Recall Bulletin

PRODUCT SAFETY RECALL

SUBJECT: Electric Power Steering Assist

MODELS: 2009-2010 Chevrolet HHR (Non-Turbo)
2010 Chevrolet Cobalt
2004-2007 Saturn ION
Equipped with Electric Power Steering

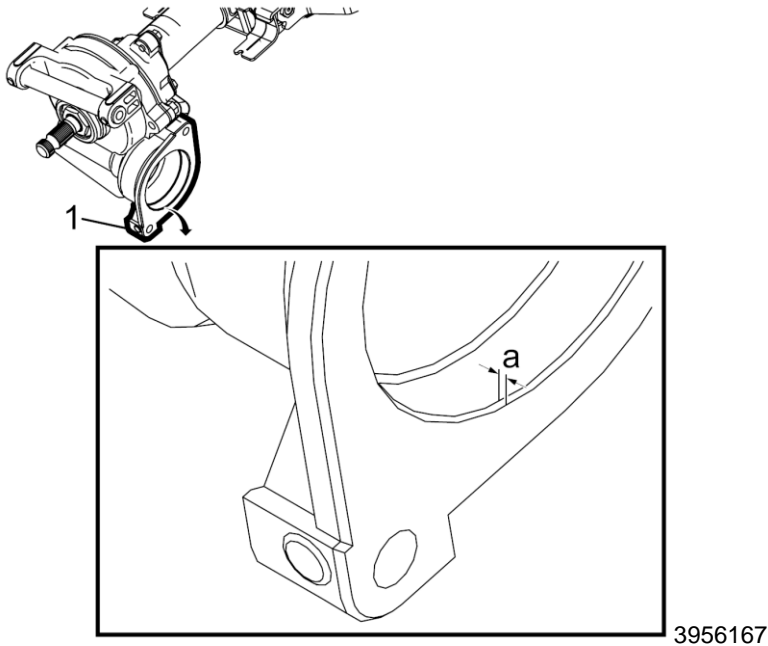
Caution: Do not install a seal on a "first design" steering motor. Installing a seal on a "first design" steering motor may damage the steering motor which may result in loss of assist steering. A seal is only required on a "second design" steering motor – the motor with the larger chamfer.

Before installing the power steering assist motor, inspect the power steering assist motor housing (1) to verify the steering column design:

- *First Design:* If the chamfer (a) is **1 mm (0.04 in)** and **30 degrees** then the steering column is the first design and a power steering assist motor O-ring seal is NOT needed.
- *Second Design:* If the chamfer (a) is **2.7 mm (0.11 in)** and **45 degrees** then the steering column is the second design and a NEW power steering assist motor O-ring seal IS needed.
